PLANNING & ZONING BOARD AGENDA

**PLANNING & ZONING BOARD
AGENDA ITEM 7A**

The applicant, Charles Cudd Co, submitted a Land Use Application for PUD Amendment #1. They are requesting an amendment to the PUD Preliminary Plan/Preliminary Plat ("PUD Amendment #1") to construct 13 single-family lots west of Wilkinson Way instead of the approved 20 townhomes lots.

TITLE

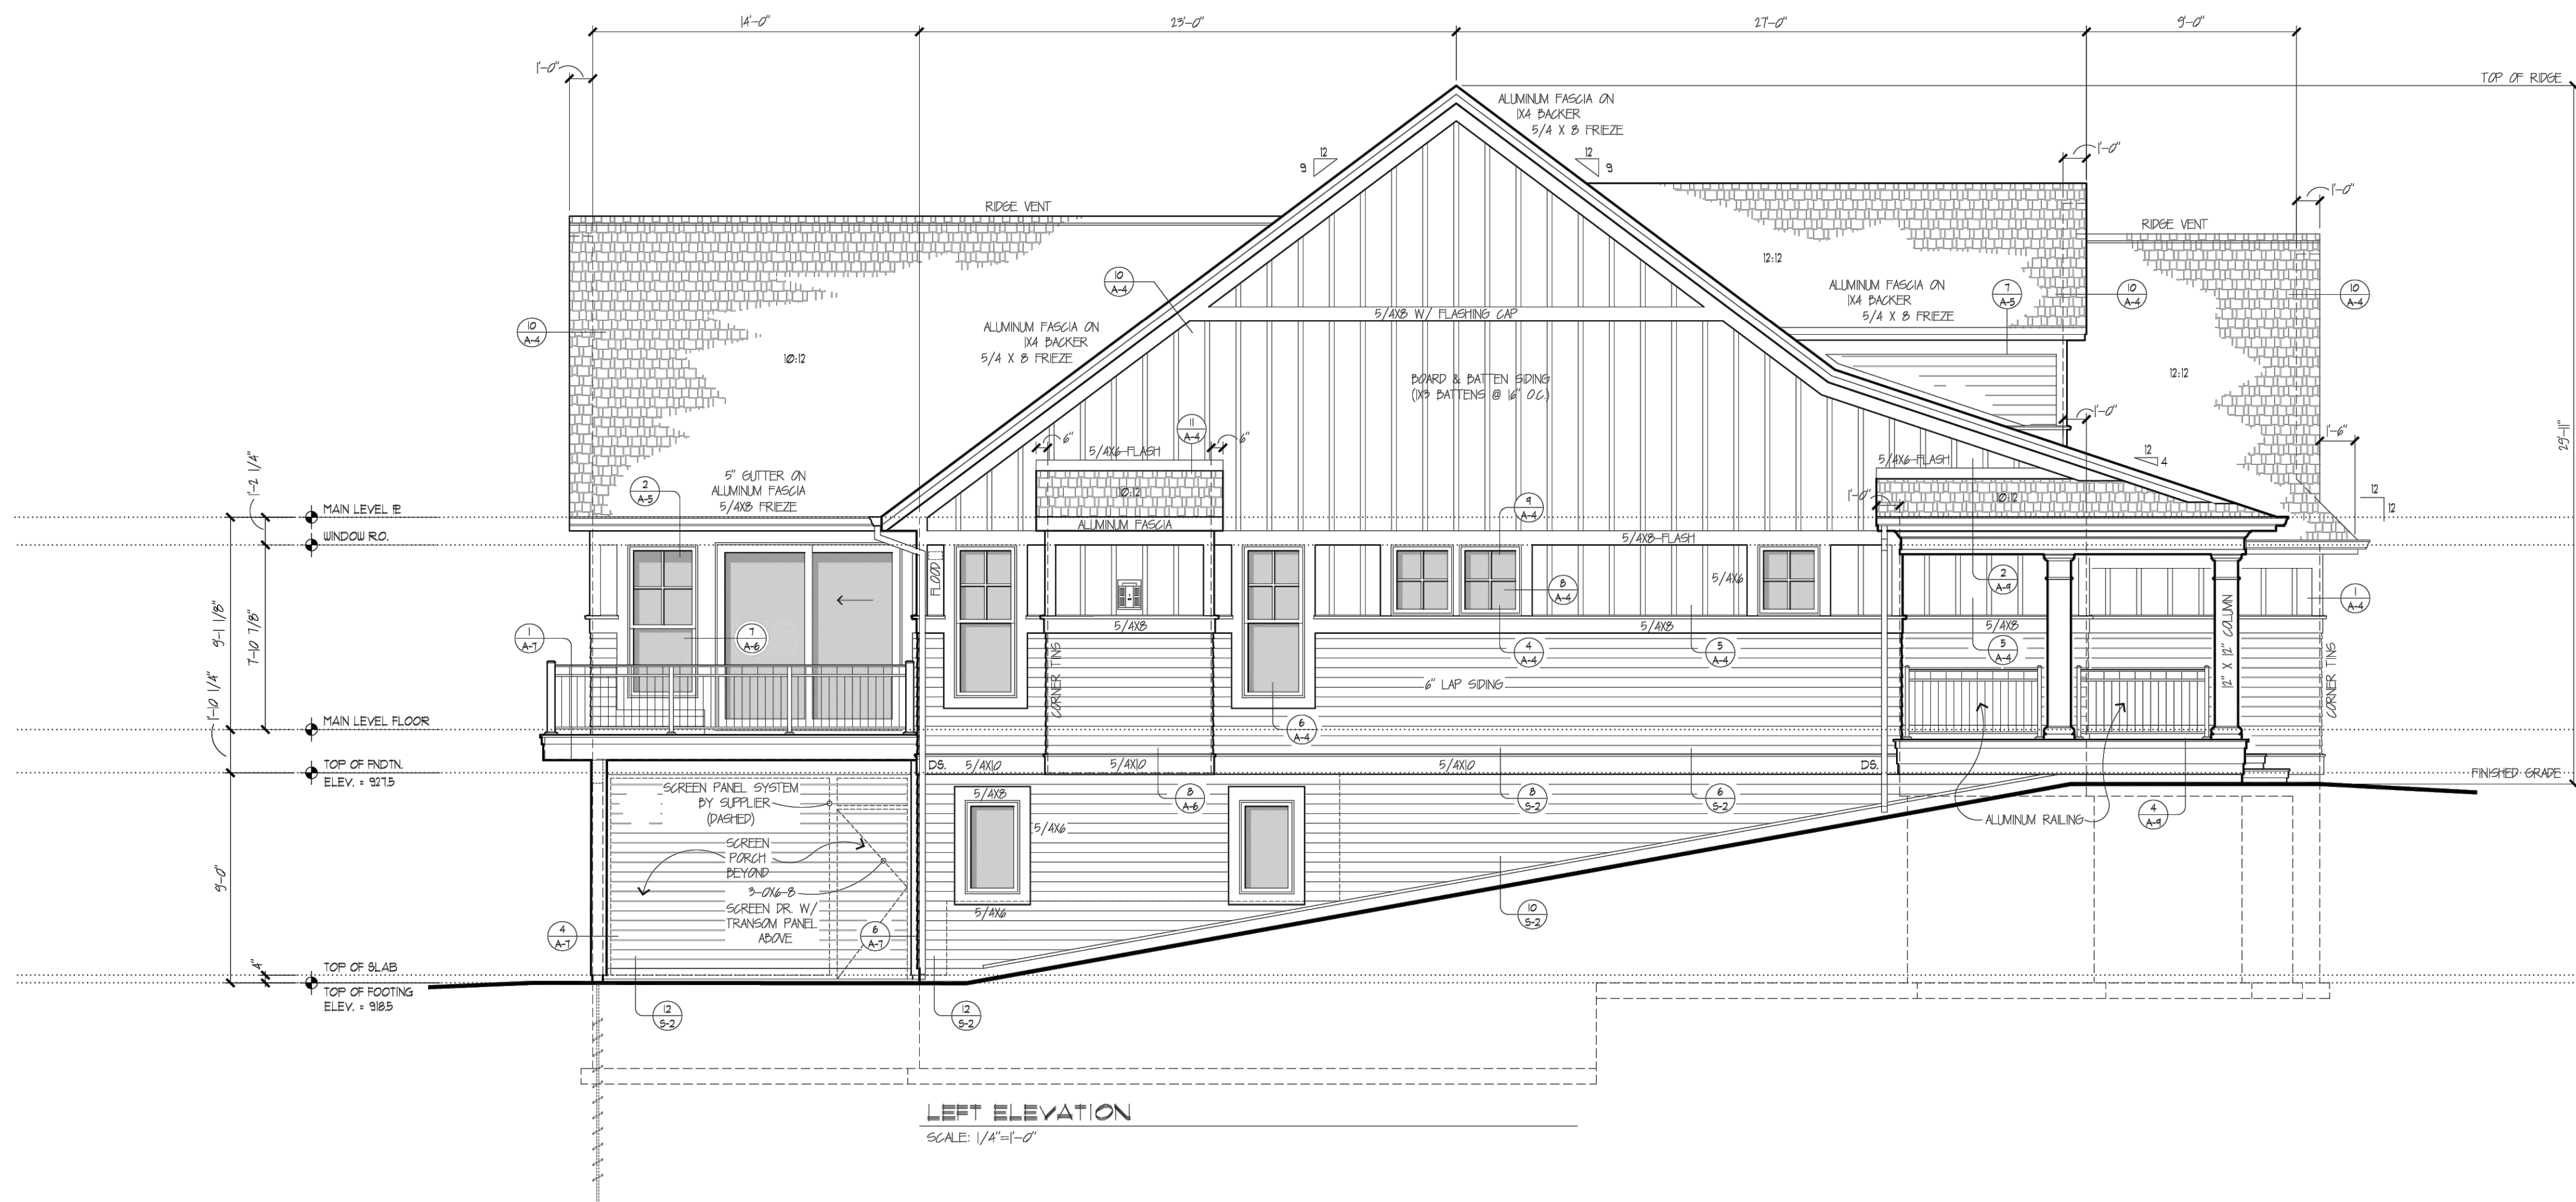
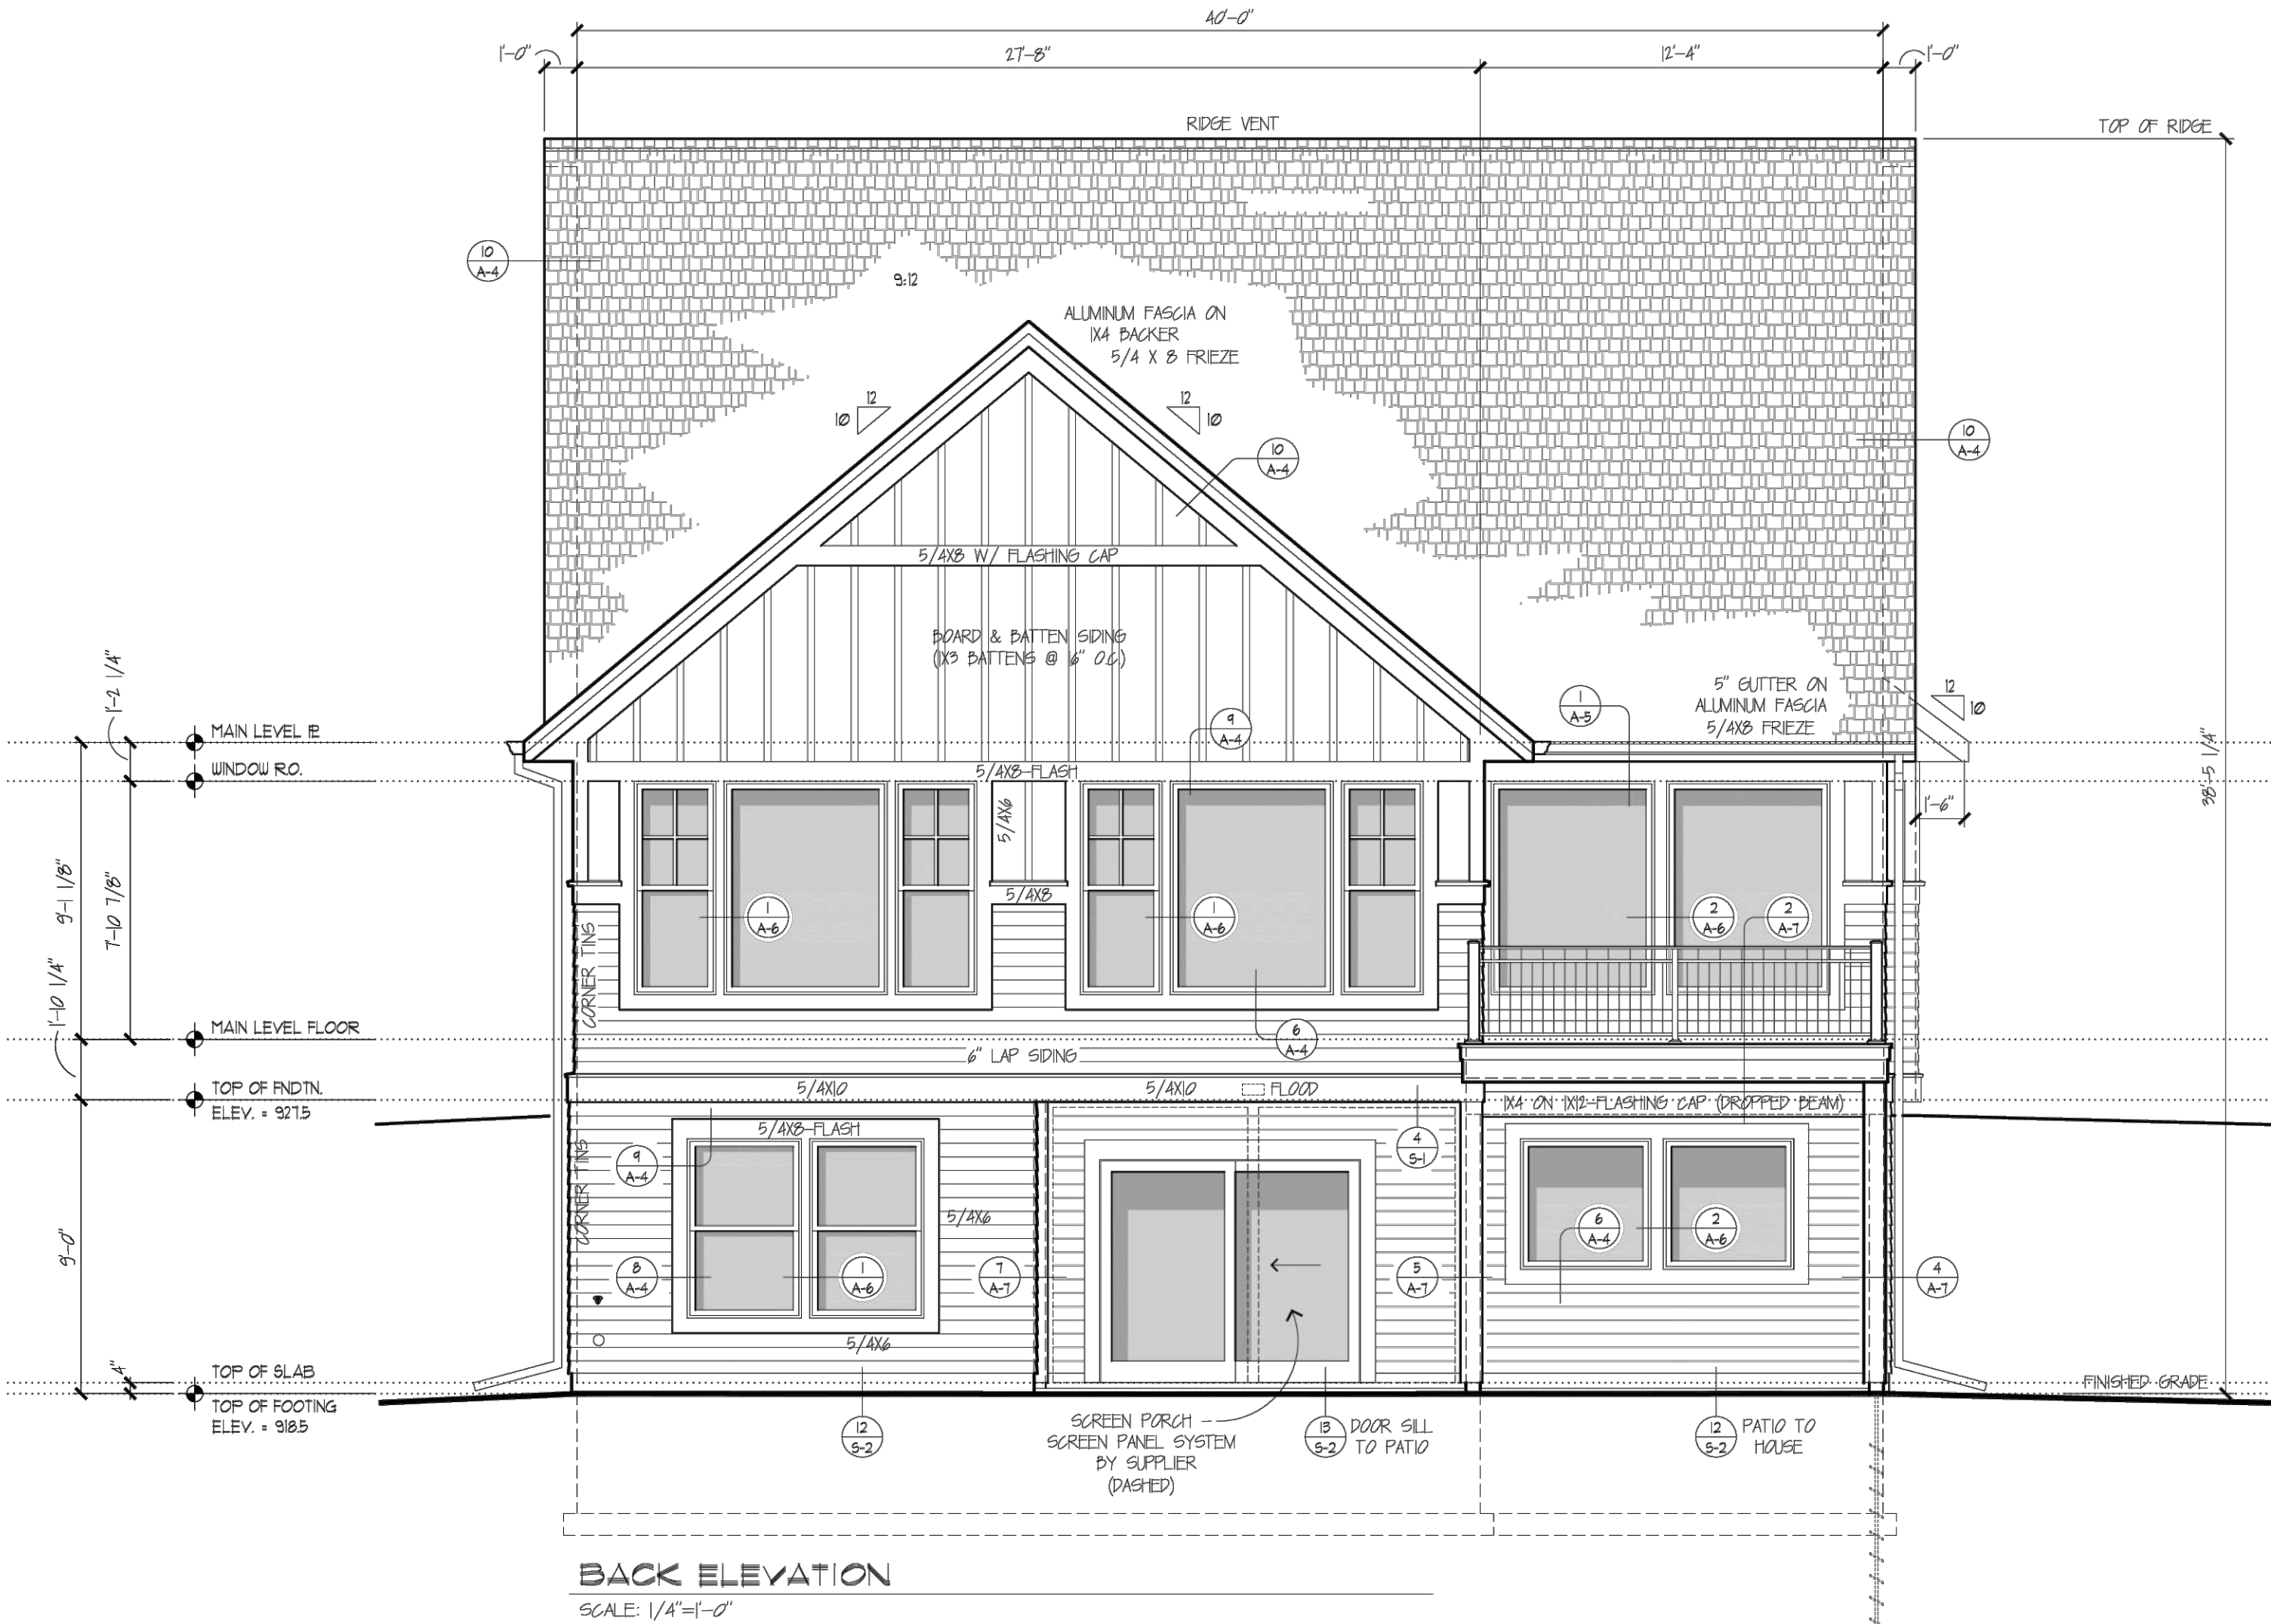
- d. Add information under Proposed Zoning for R-2 requirements.
- 6. All plan sheets for Charles Cudd Co architecture plans:
 - a. Plans shall be to scale.

- b. Plans shall represent house plans that are proposed for construction.
 - c. Air conditioning units shall not be in drainage & utility easements. These may need to be moved to rear yard.
